# Supplement to

## Operation, Maintenance, and Service Manual (TM-218, 2nd printing) and Schematic Package (SP-218, 2nd printing)

### RAM Battery Back-Up Power

Figure 3-16 Central Processing Unit (CPU) Printed-Circuit Board Assembly  
A039185-21 B

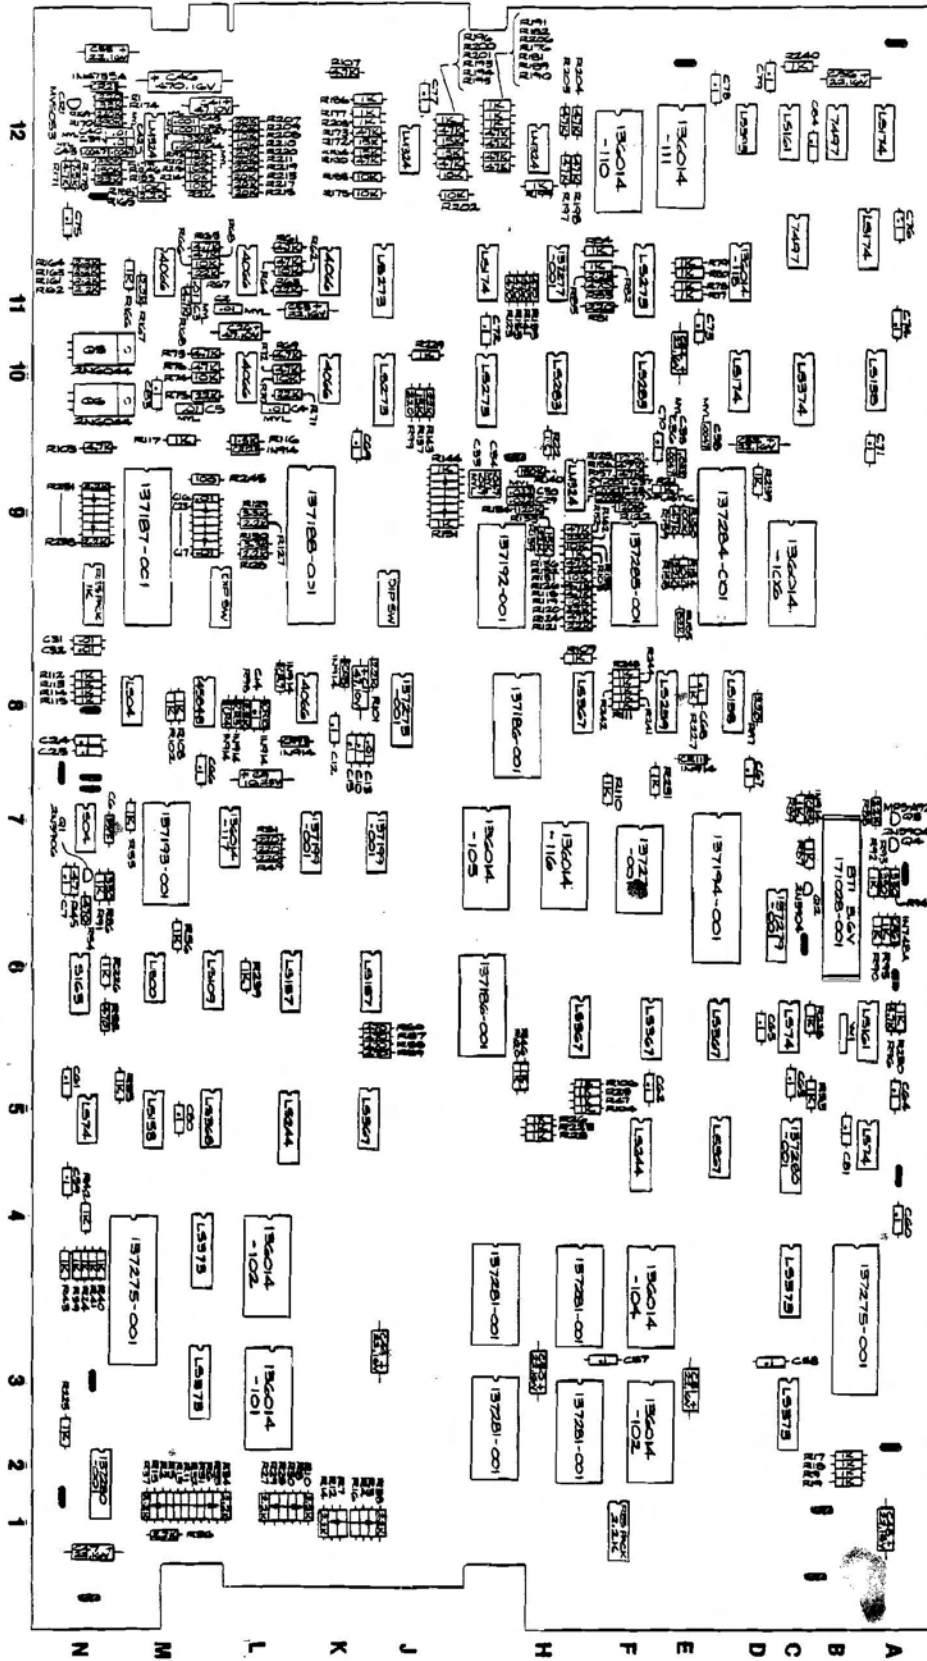
The printed-circuit board assembly drawing on the reverse side replaces page 3-32 of your manual.

In addition, diode CR6 (see sheet 4B of SP-218 and page 3-33 of TM-218) has been changed. It is now part number 13000-002, a 3.9-volt,  $\pm 5\%$ , Type-1N748A zener diode.
